Notice of Modification

The project approval (08_0101) granted by the Minister for Planning on 26 November 2010 for the Integra Underground Project.

Figure 4: Approved Middle Liddell Seam - Longwall Panels (330 m width for Longwalls 15 – 19)

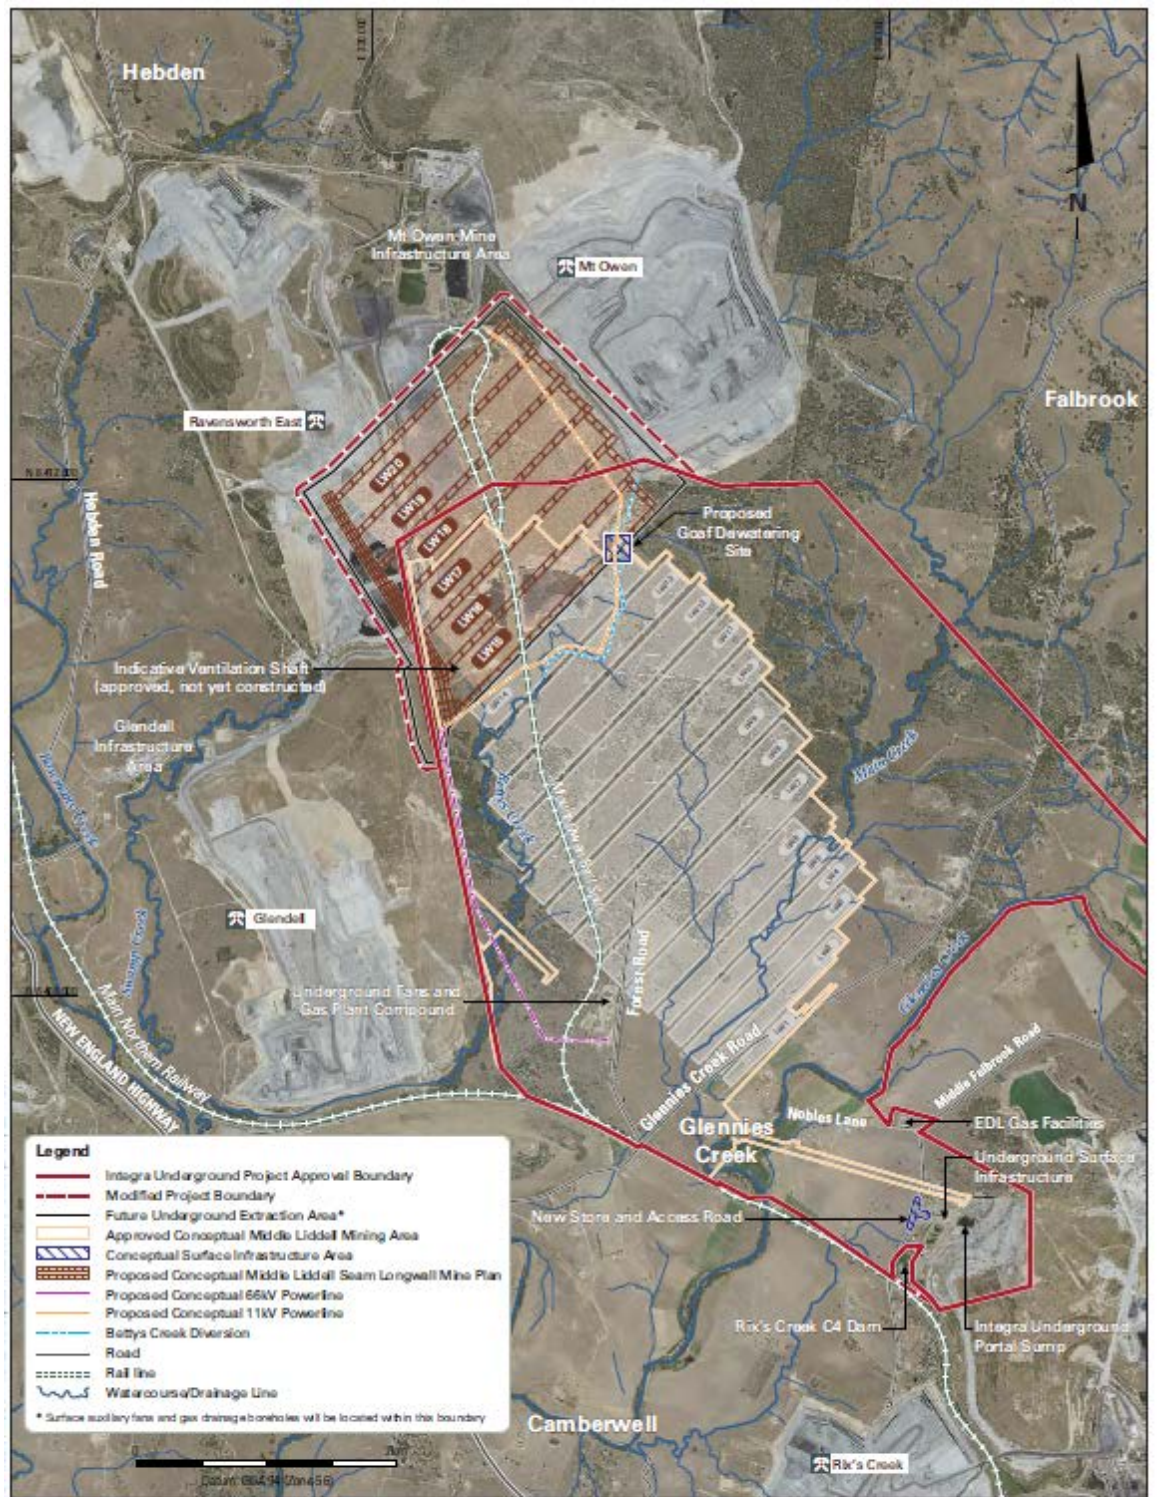
- 11. Delete Figure 2 in Appendix 3.
- 12. In Appendix 3, following Figure 3, insert the following:
